EPC STORMWATER REVIEW COMMENTS
IN ORANGE BOXES WITH BLACK TEXT

MERIDIAN STORAGE

CONSTRUCTION DRAWINGS

CONSTRUCTION DRAWINGS
MERIDIAN STORAGE
MERIDIAN STORAGE, LLC
STATE OF COLORADO
EL PASO COUNTY, FALCON, CO 80931
ADDED FILING NUMBERS
SF-23-XXX
VR239

COVER SHEET

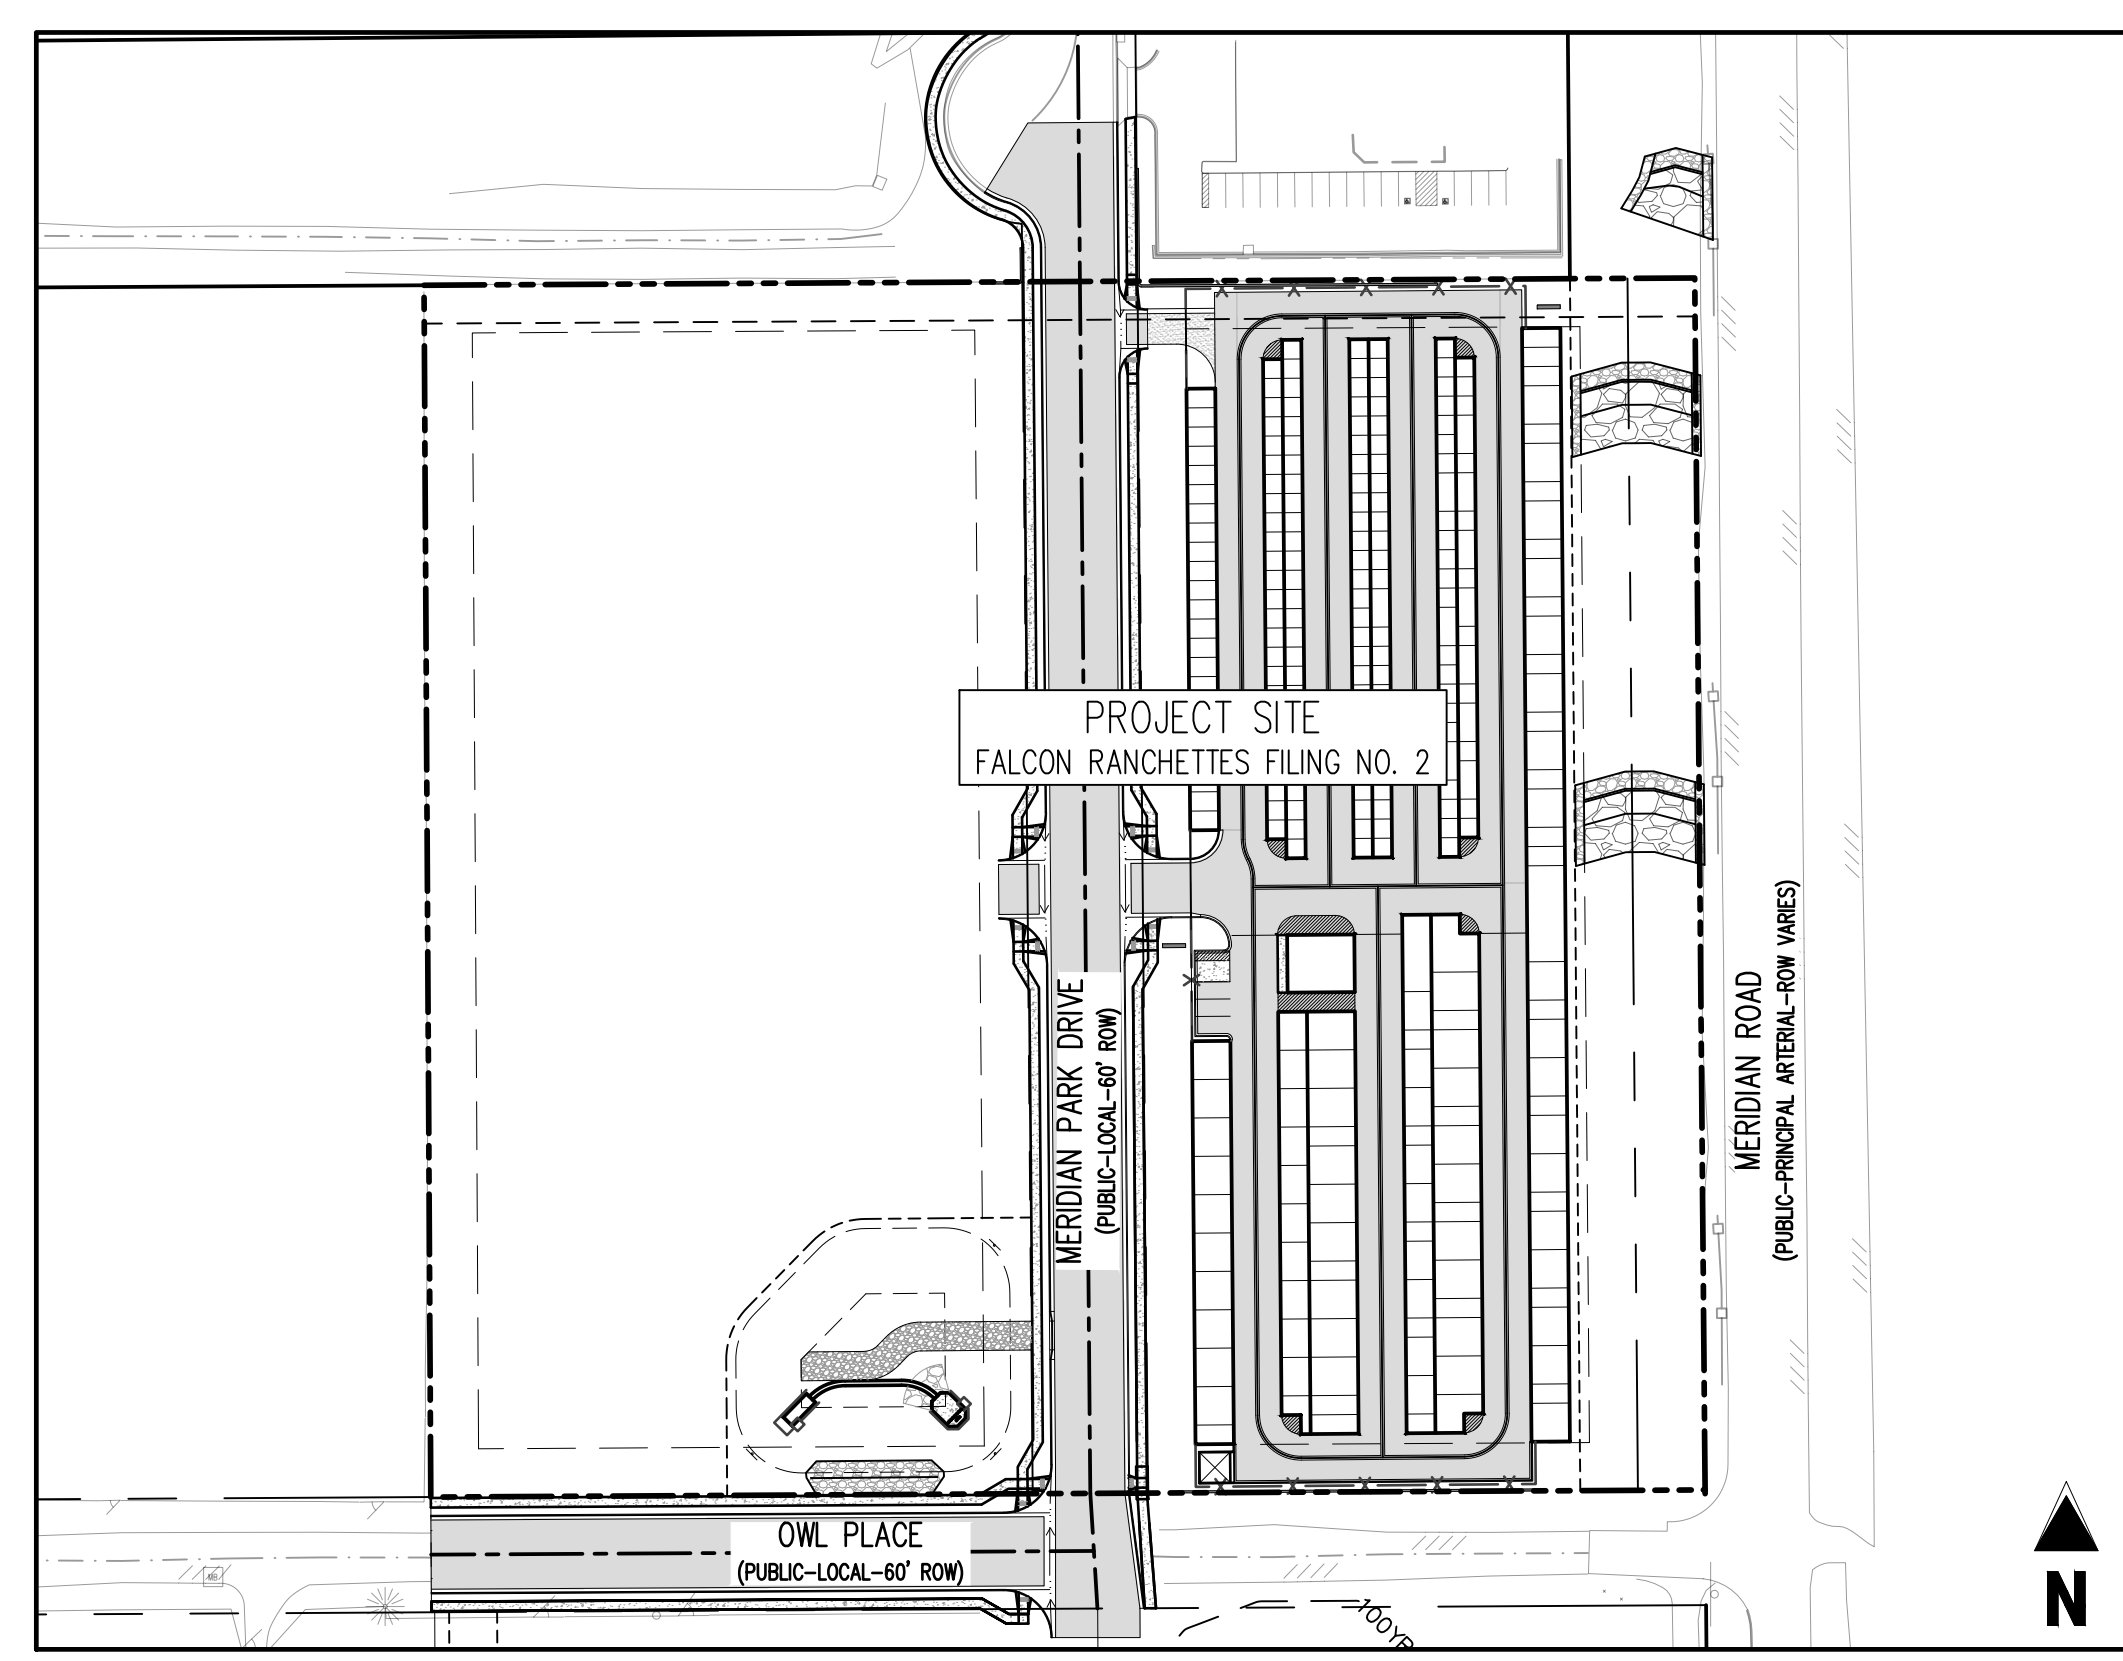
Add PCD File
#VR239

ADDED
FILING
NUMBERS

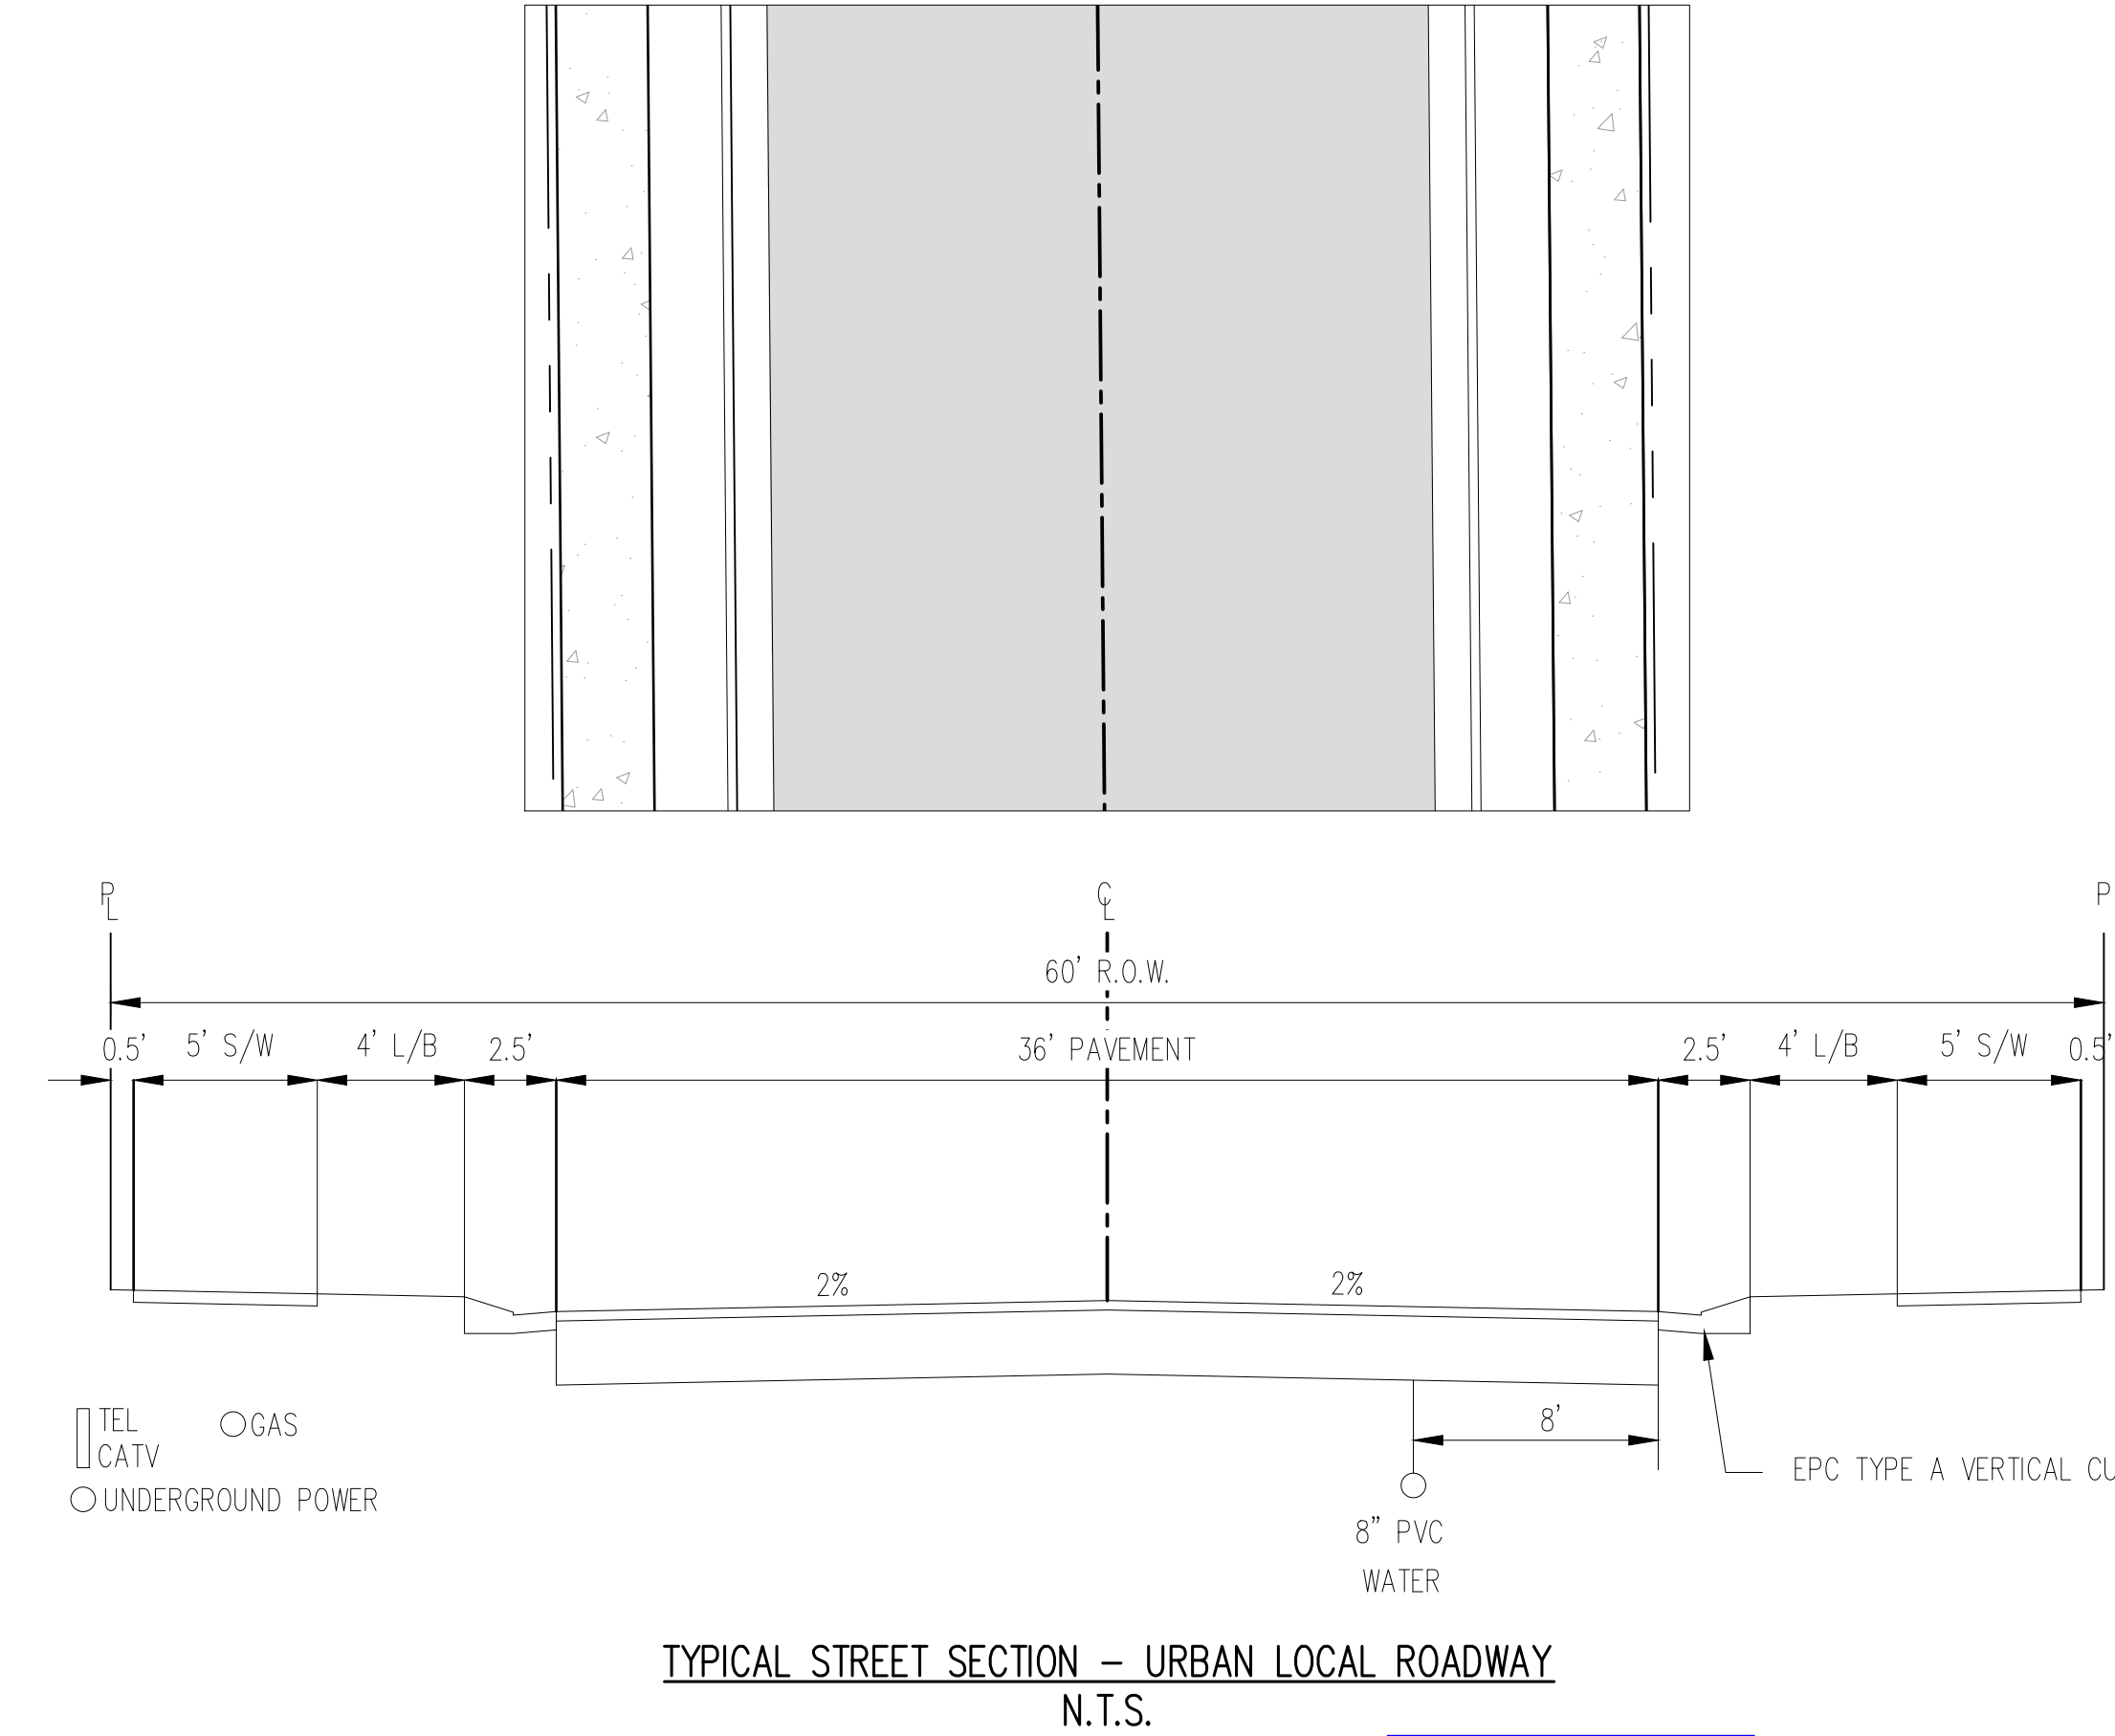
Add design and posted speed note 25/25mph

ADDED DESIGN AND POSTED SPEED LIMITS

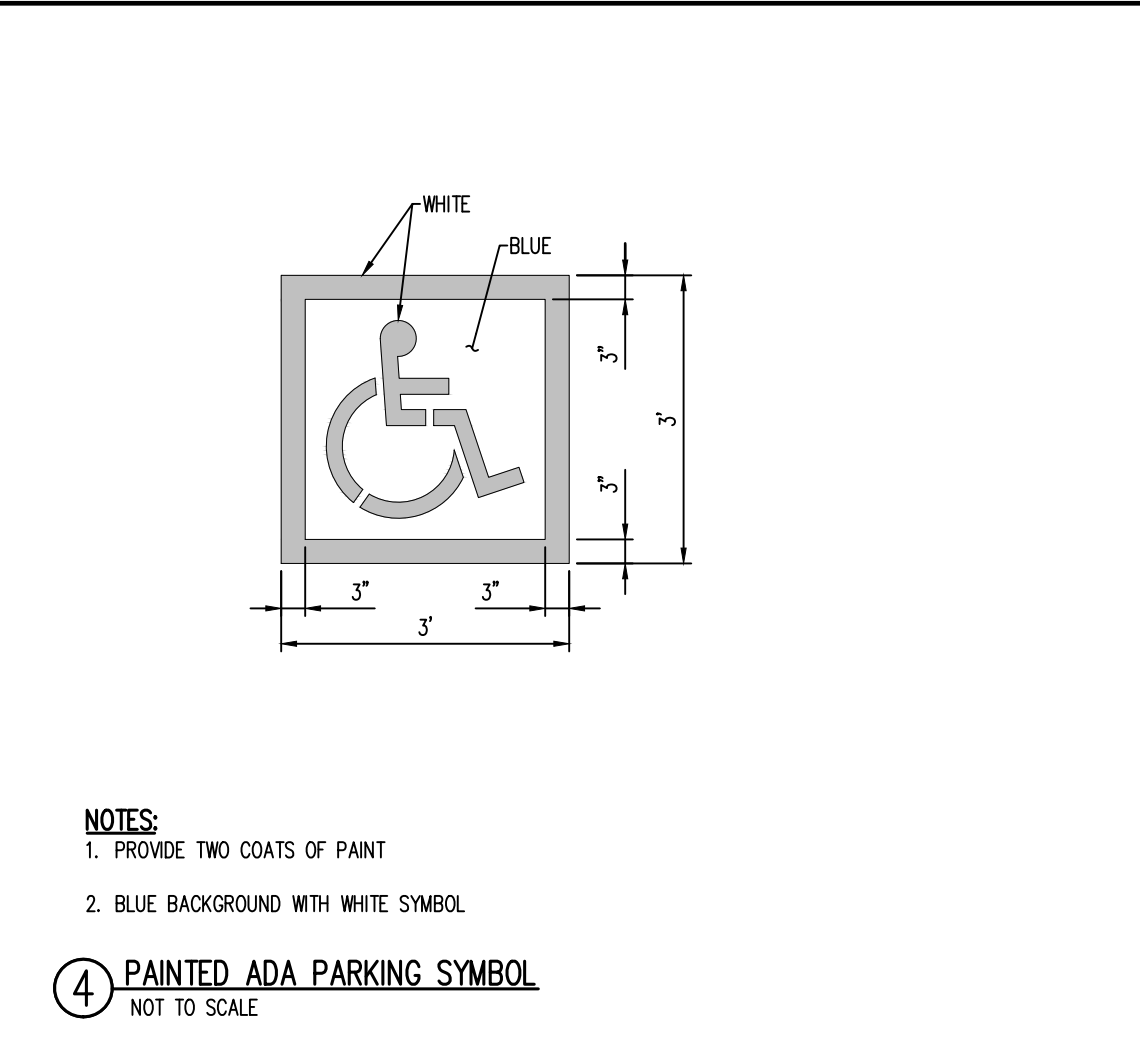
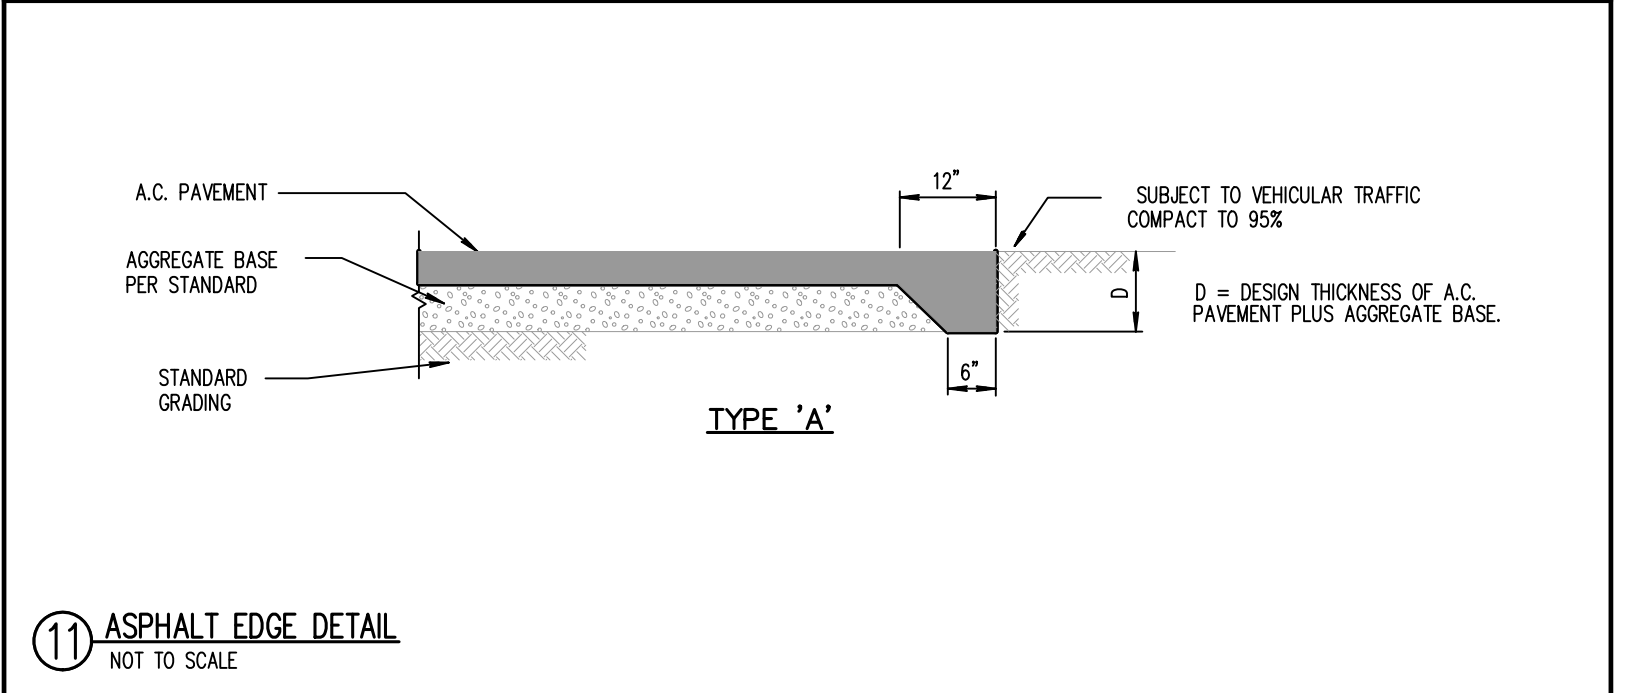
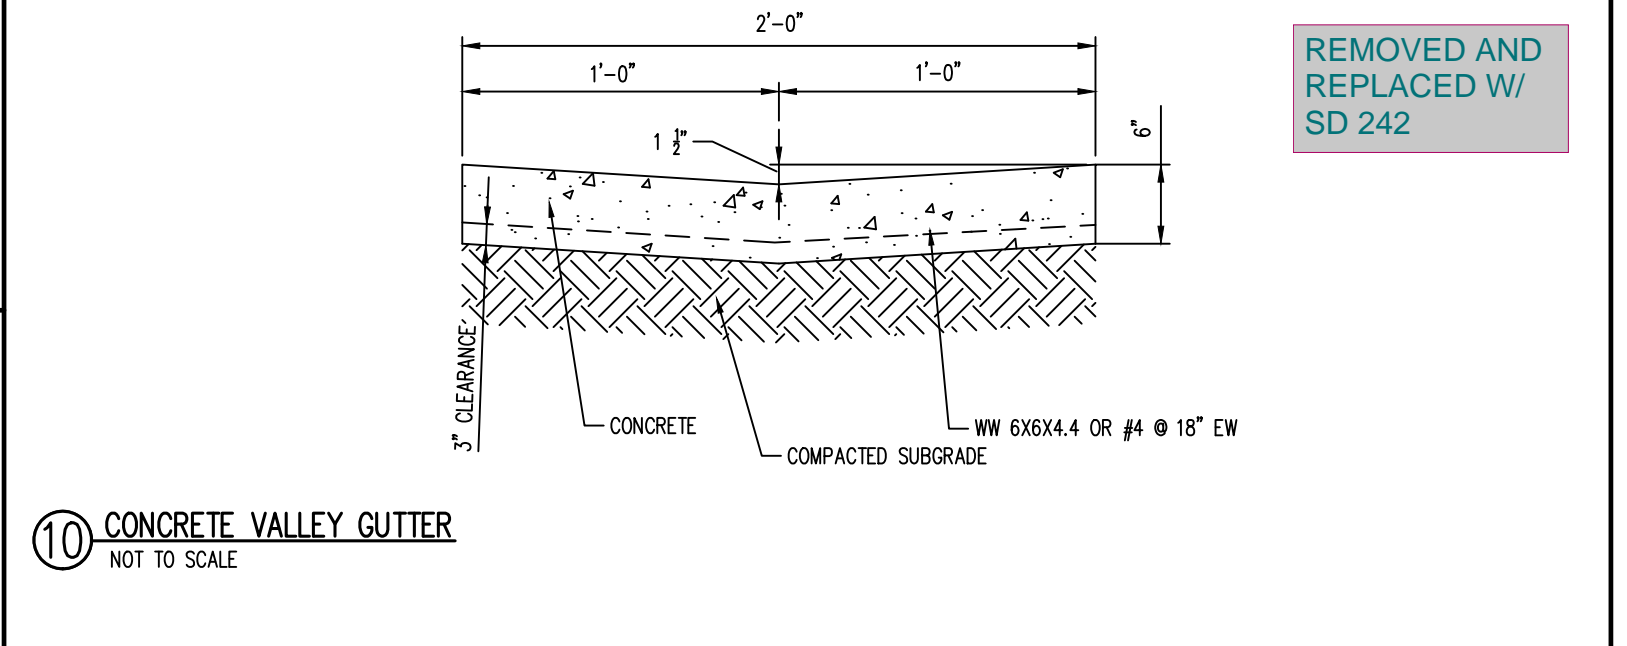
Use County detectable warning detail SD_2-42 from ECM Appendix F

REMOVED AND REPLACED W/ SD 242
